10/579,343

Office Action Summary	Application No.	Applicant(s)	
	10/579,343	PRIOUL ET AL.	
	Examiner	Art Unit	
	JEFFREY ALLEN	3781

DETAILED ACTION

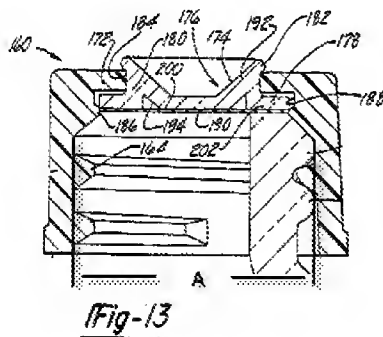
12. Regarding claim 4, the modified closure of Gach teaches the maximum radial dimension of the membrane being less than the outside diameter of the lip (lip is designated by A in drawing below labeled by examiner).
